ENGINE - HP COMPRESSOR SPLIT CASES - INTRODUCTION OF REVISED STAGE 5 AND 6 BOROSCOPE
BLANKING PLUG WITH ADDITIONAL ATTACHING BOLT - CATEGORY CODE 6 - MOD.ENG-72-0317

V2500-ENG-72-0317

Rework of the Stage-5 and 6 Boroscope blanking-plug
Fig.1

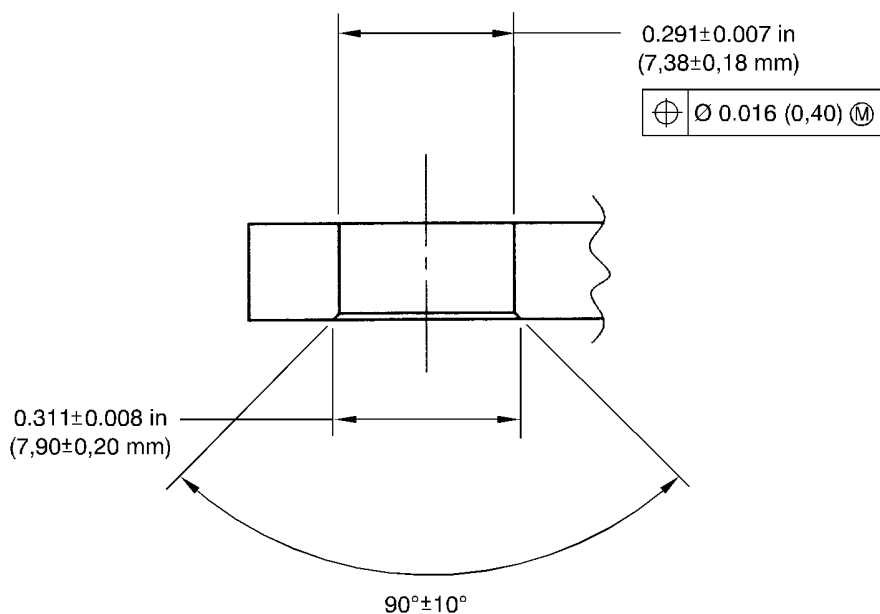
(a) The number of bolts holes has been increased from one to two.

(b) The quantity of bolts to attach the Stage 5 and 6 boroscope blanking plug to the front case assembly of the HP Compressor has increased from one to two.

(2) The existing Stage-5 and 6 boroscope blanking-plugs can be reworked. (Refer to Section 2. and Figure 1).

With the scribing tool and a locally manufactured template, mark off the position of the new bolt hole.

With a drilling machine with standard workshop equipment, drill the new bolt hole.

With standard workshop equipment, remove any burrs and break off any sharp edges.

With CoMat 06-022 fluorescent penetrant and penetrant crack test equipment, do a local penetrant crack test of the reworked area.

Reject the blanking plug if any cracks are found.

With the vibro-engraving equipment, cancel the existing part number and identify with the new part number.
